## ADDENDUM

**ADDENDUM NO.:** 01  
**PROJECT NAME:** CIP Central Hearing Facility Roof and MEP Upgrades  
**PROJECT NO.:** 04044  
**CONTRACT NO.:** C1606  
**DATE OF ISSUE:** December 21, 2023

### NOTICE OF CHANGES, MODIFICATIONS, OR CLARIFICATIONS TO CONTRACT DOCUMENTS

**1 SECOND FLOOR WEST REFLECTED CEILING DEMOLITION PLAN**  
SCALE: 1/8" = 1'-0"

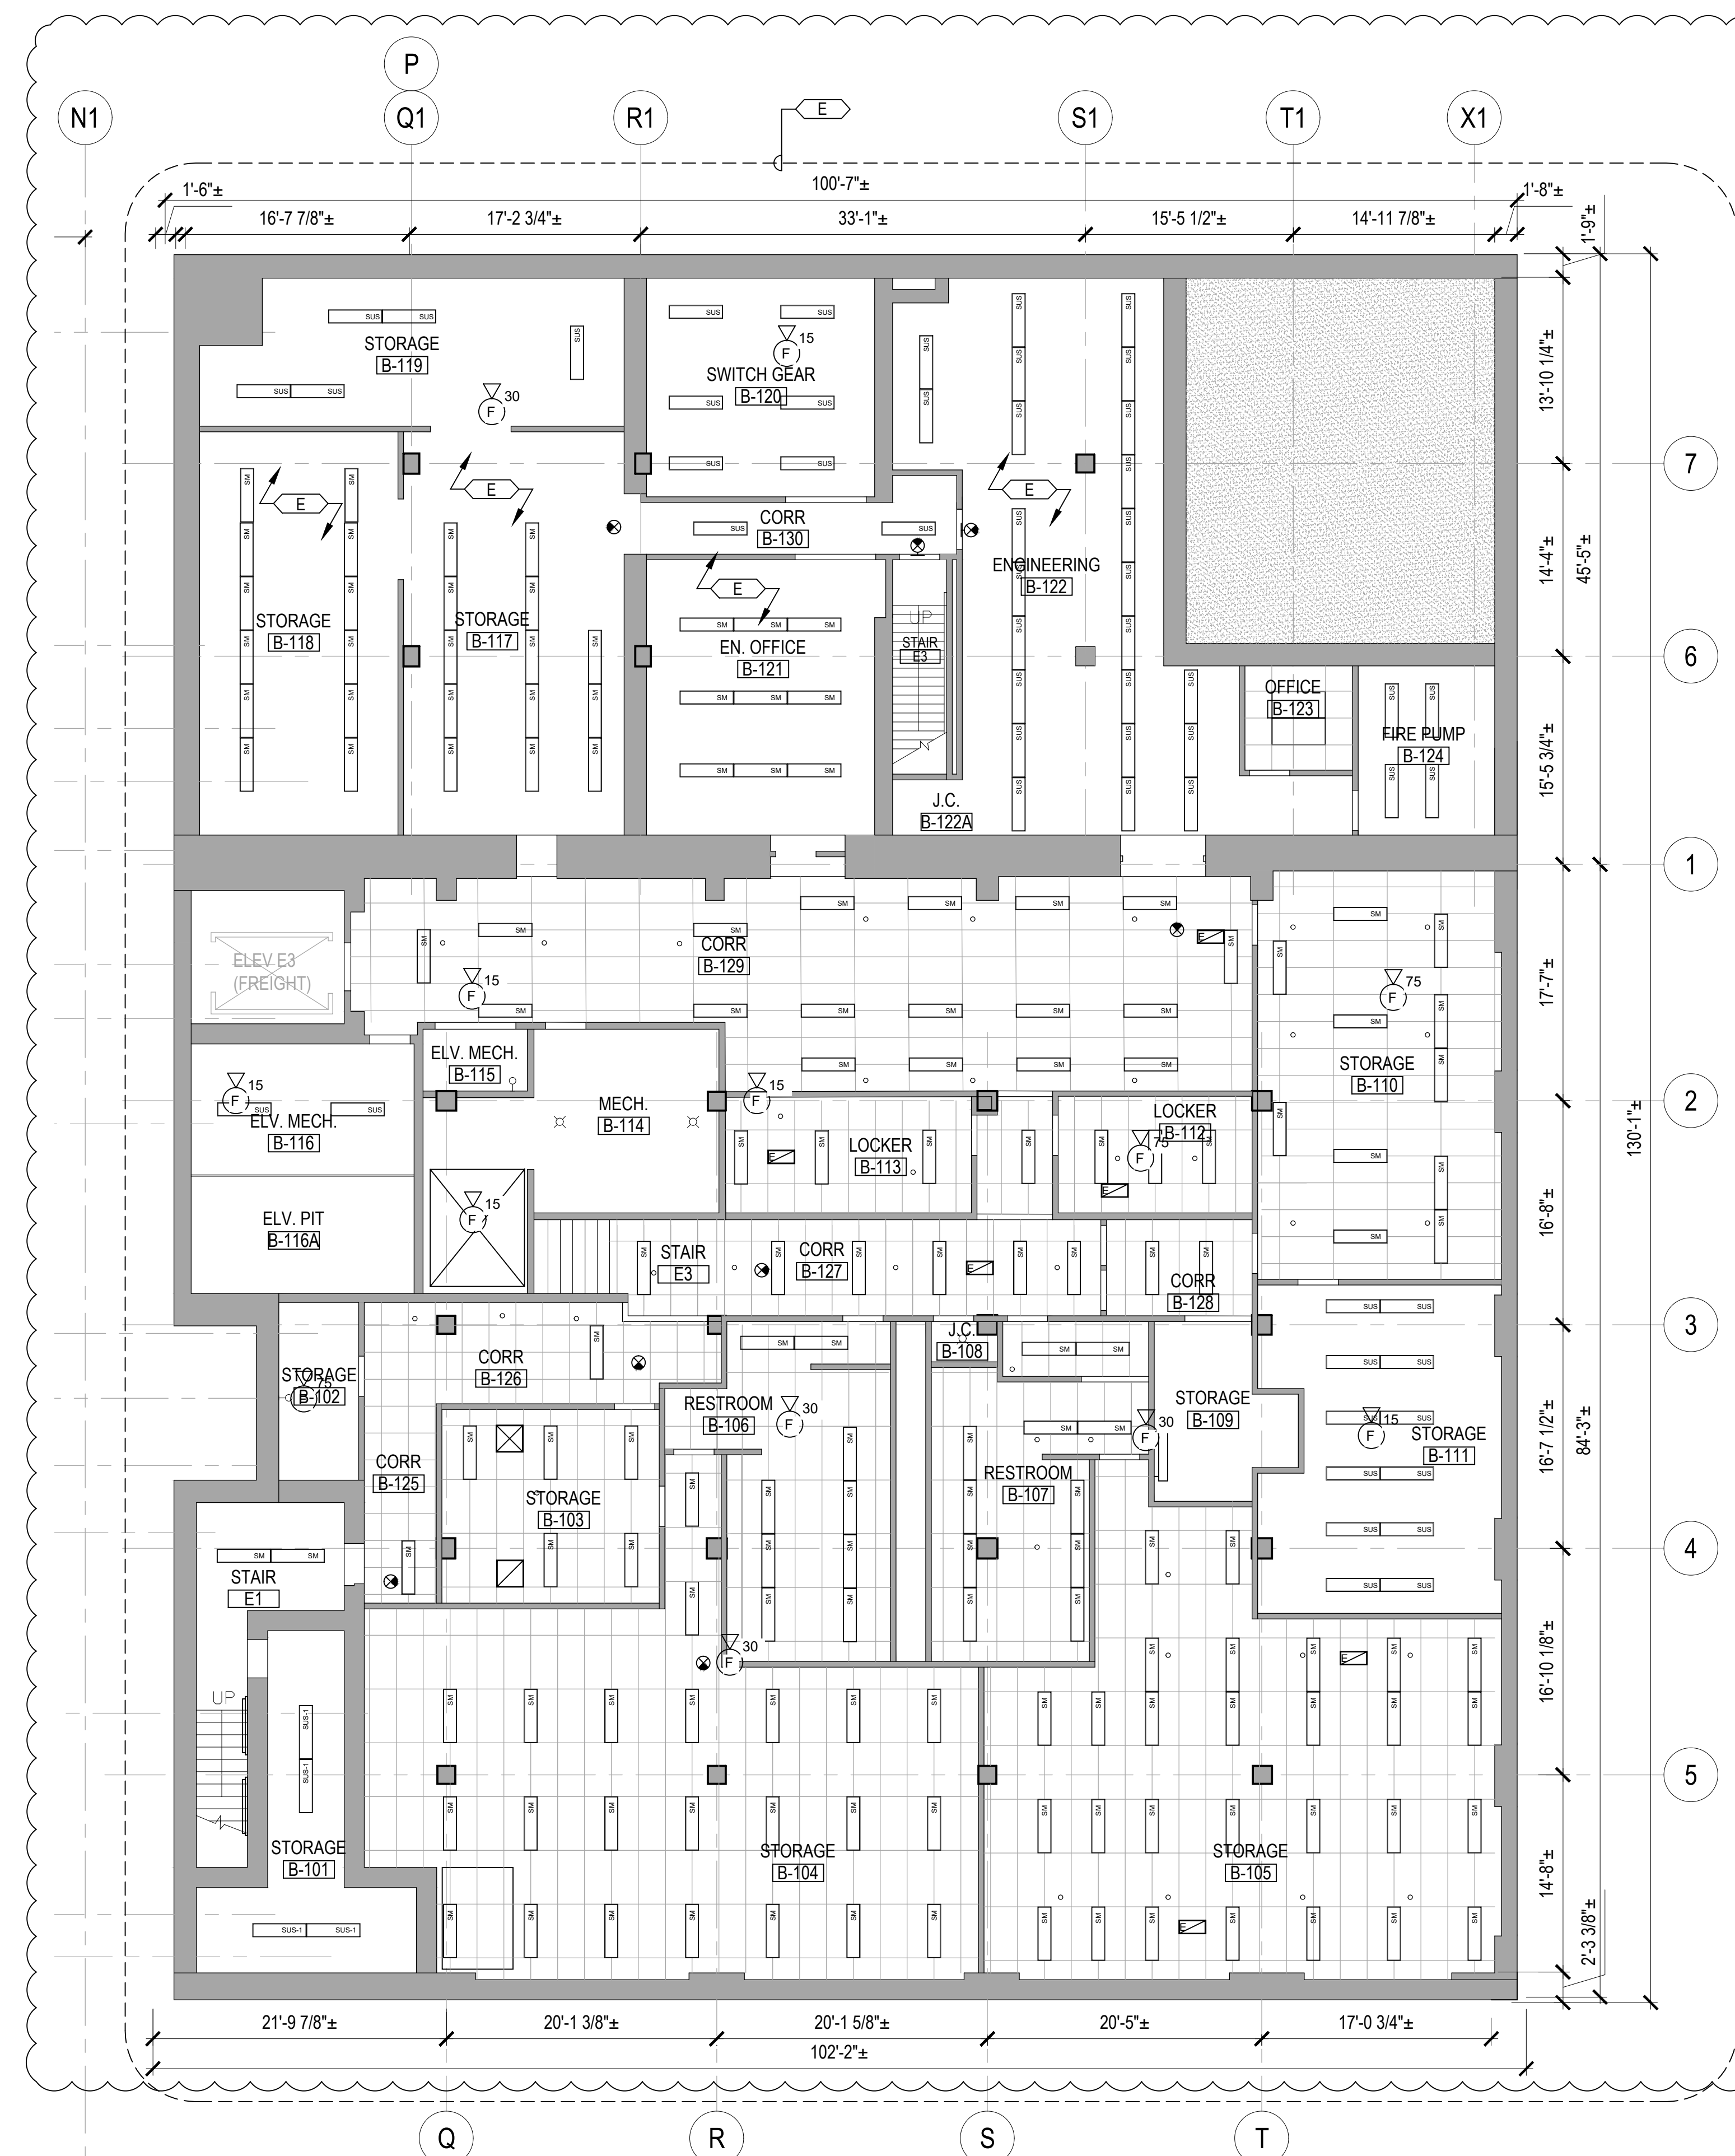
**Change 5** Drawing No. ACD-102W – **REVISED** sheet to add existing ceiling hung devices, dated 12.21.23  
**Change 6** Drawing No. AC-100 –**REVISED** sheet to add existing ceiling hung devices, dated 12.21.23

**Response:** [Ceiling plans have been revised to identify the ceiling-mounted exit signs and fire alarm devices. Please refer to architectural drawings included in this addendum.](#)

**1 FIRST FLOOR EAST REFLECTED CEILING NEW WORK PLAN**  
SCALE: 1/8"=1'-0"

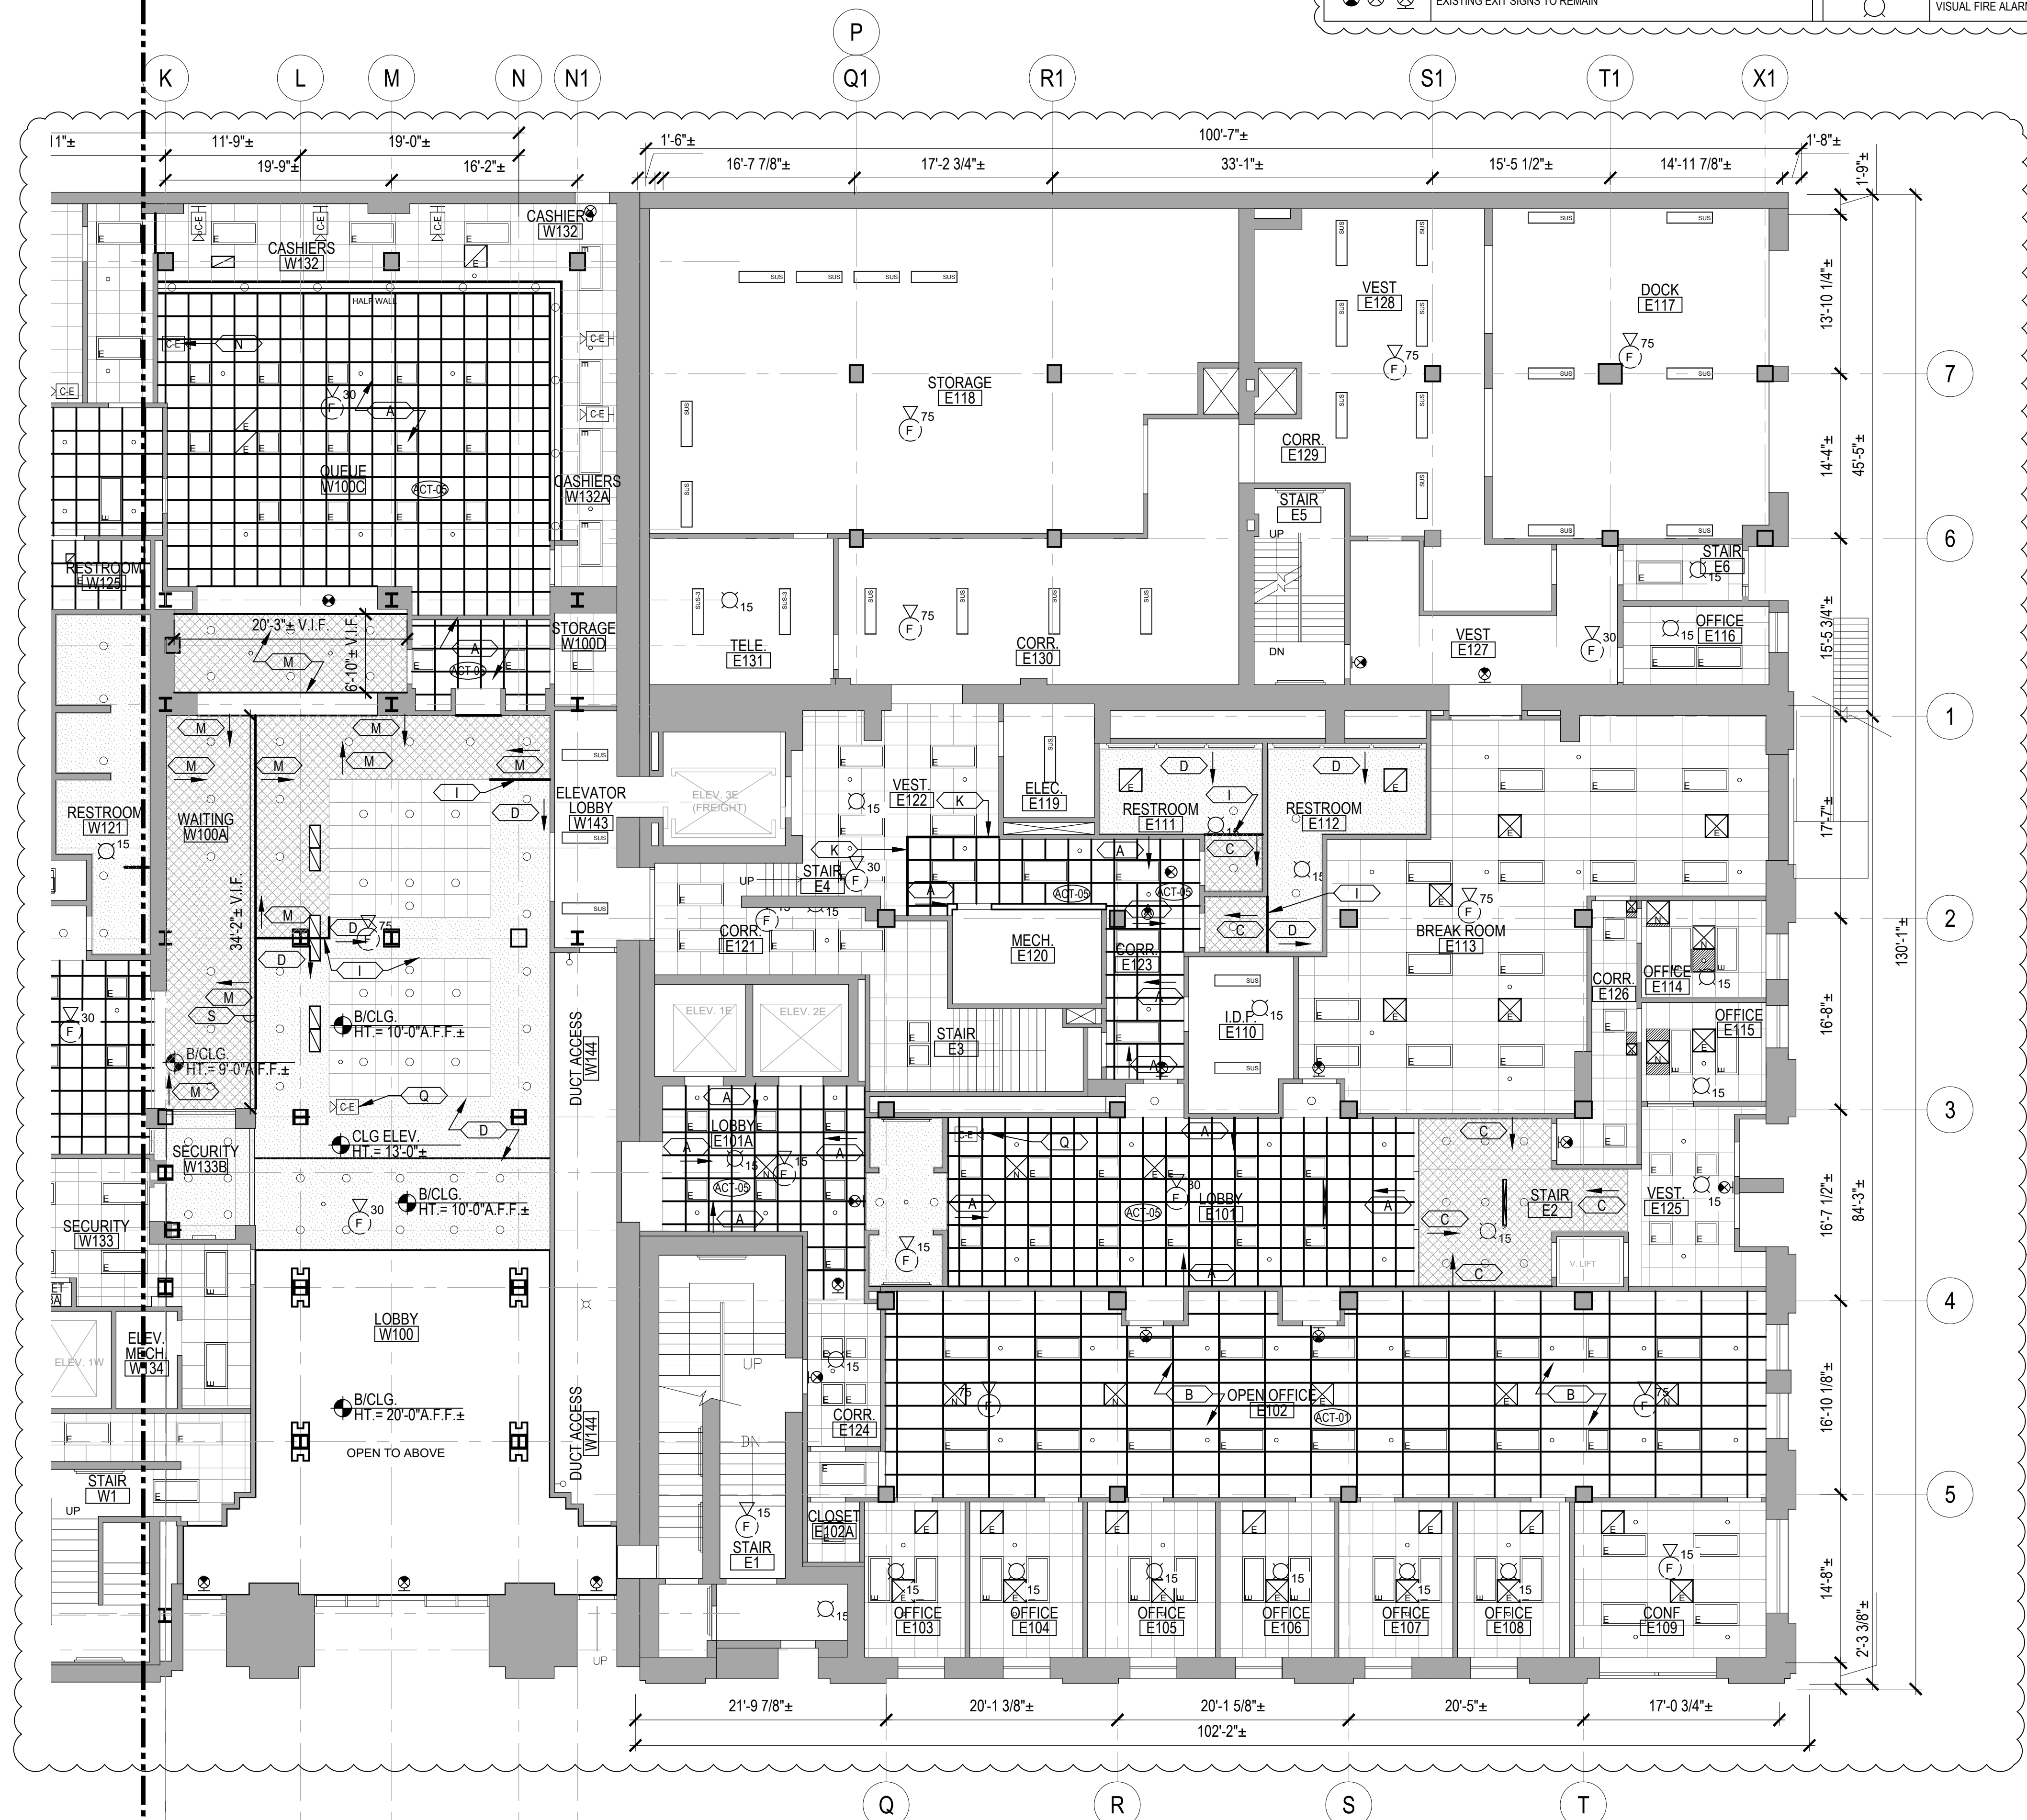
**Change 7** Drawing No. AC-101E –**REVISED** sheet to add existing ceiling hung devices dated 12.21.23  
**Change 8** Drawing No. AC-101W –**REVISED** sheet to add existing ceiling hung devices dated 12.21.23

**1 SECOND FLOOR EAST REFLECTED CEILING NEW WORK PLAN**  
SCALE: 1/8" = 1'-0"

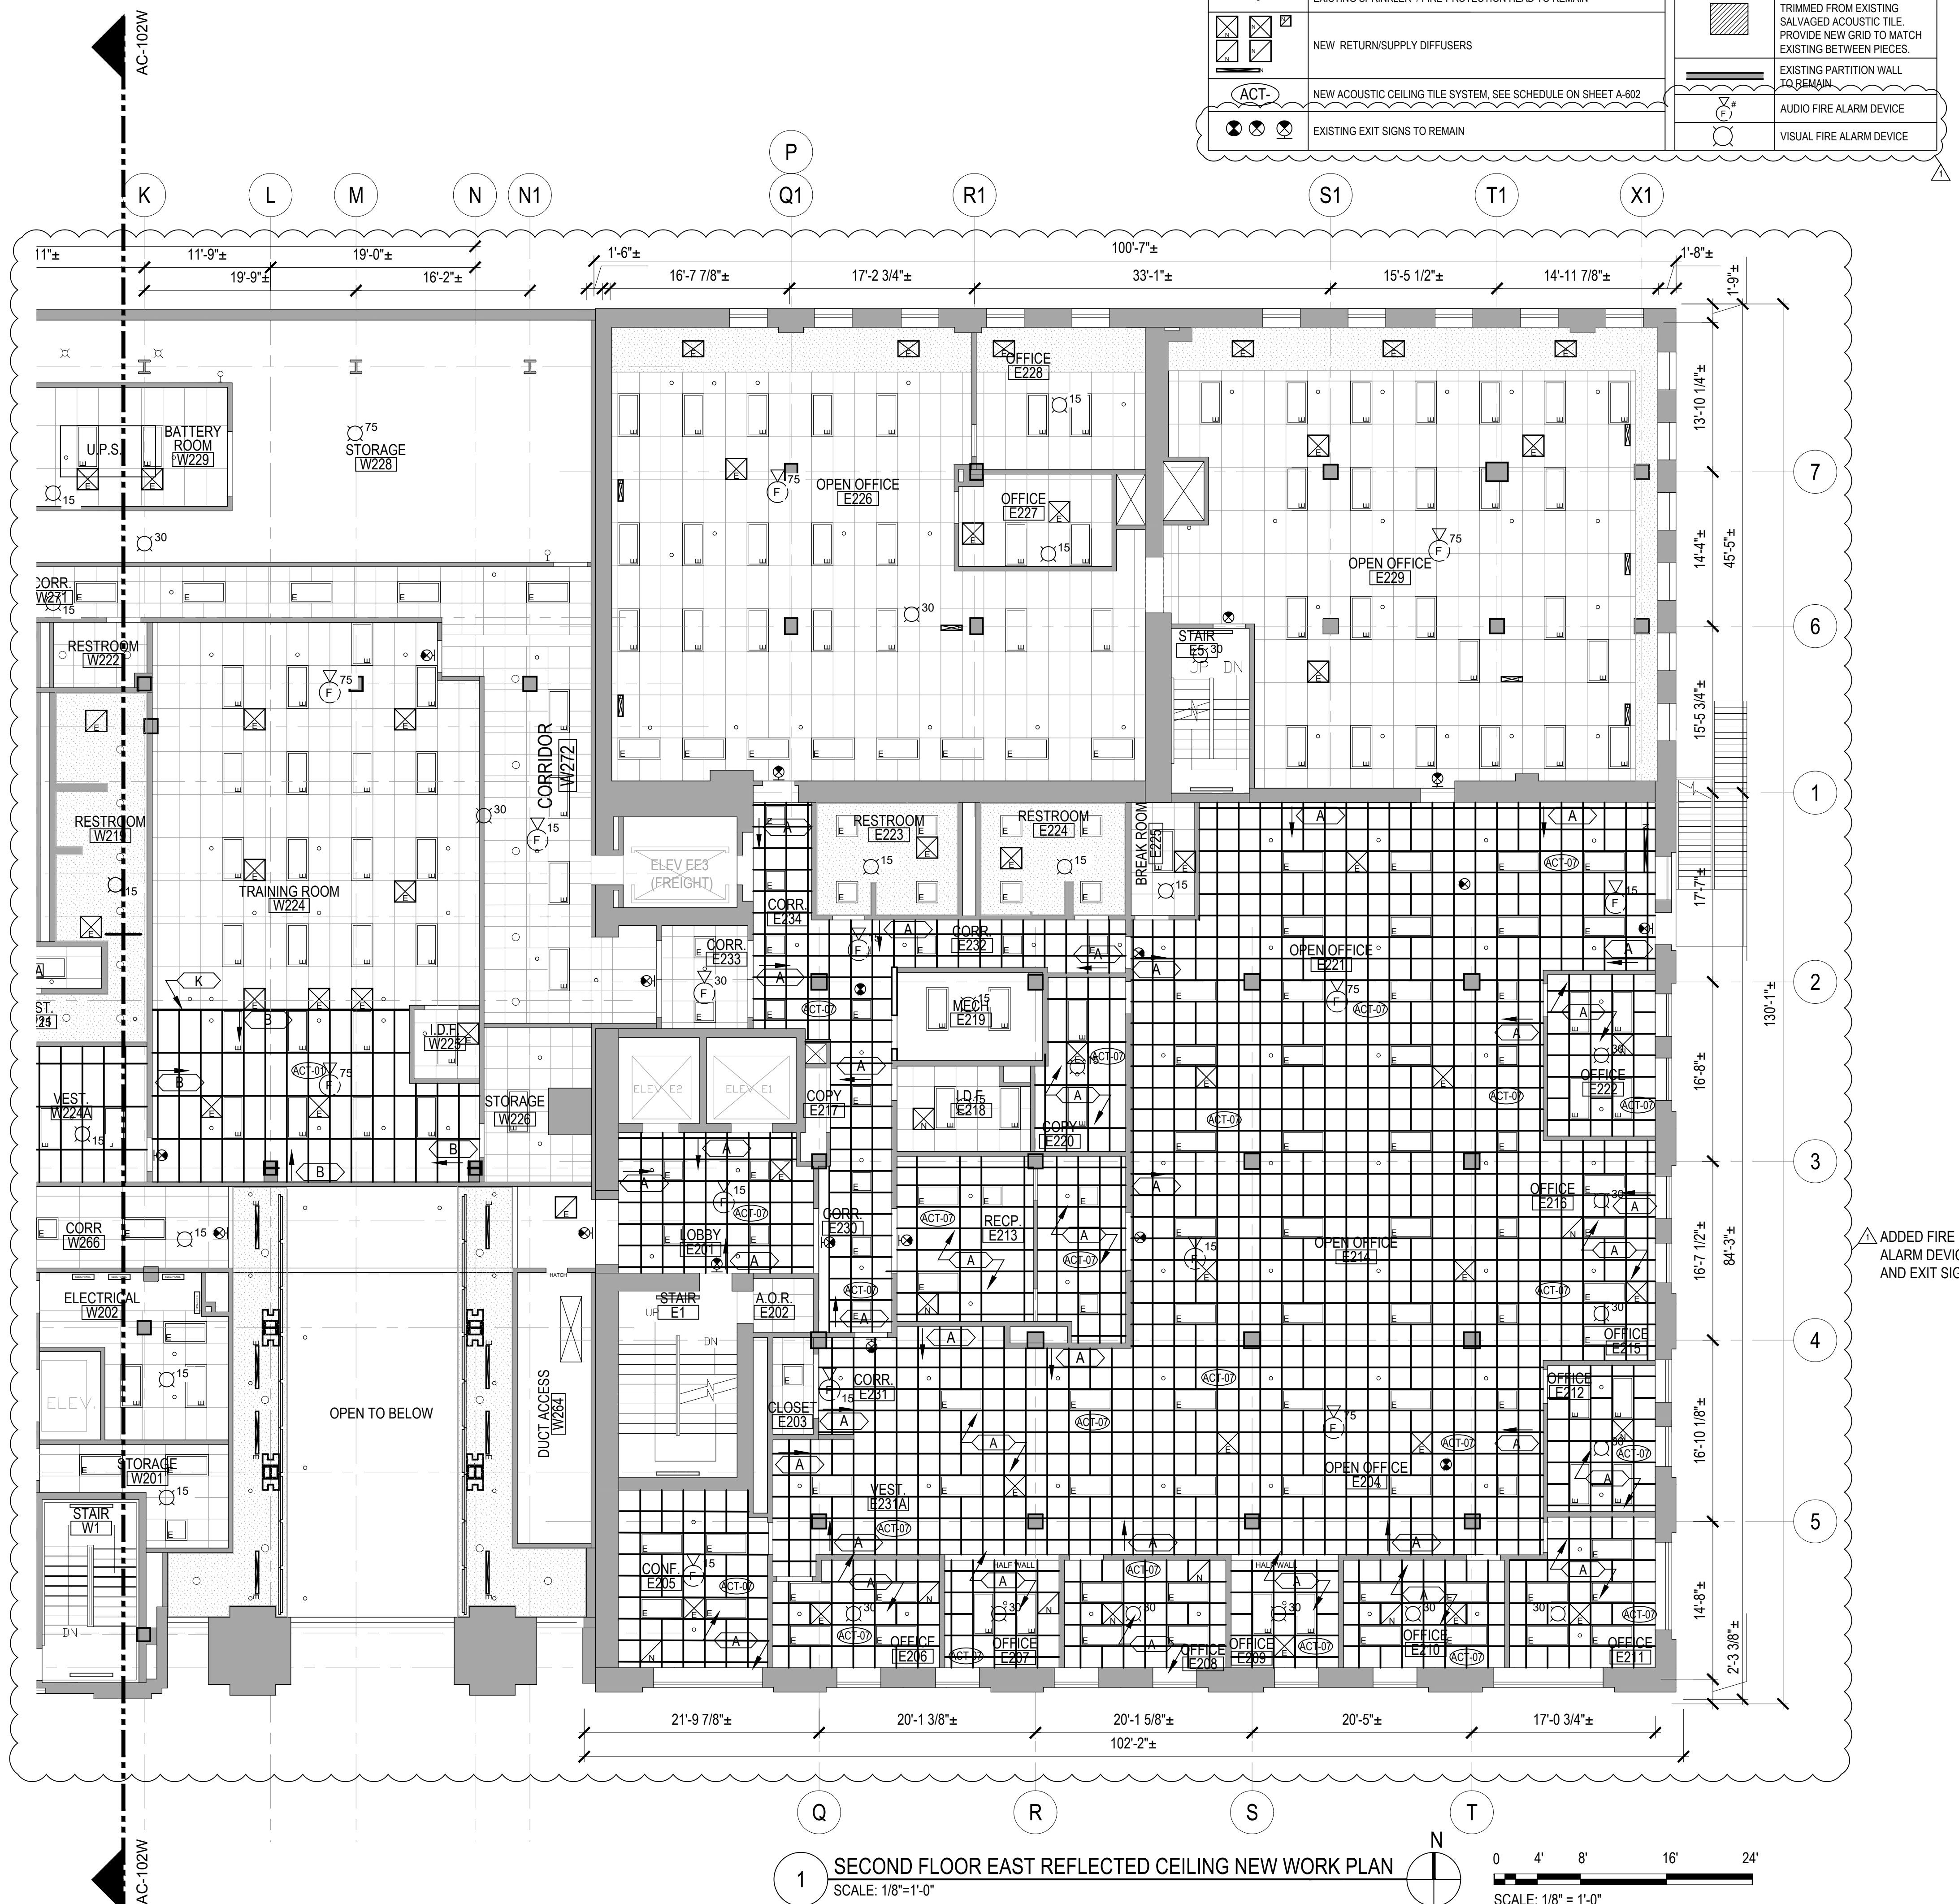
**Change 9** Drawing No. AC-102E –**REVISED** sheet to add existing ceiling hung devices dated 12.21.23  
**Change 10** Drawing No. AC-102W –**REVISED** sheet to add existing ceiling hung devices., dated 12.21.23
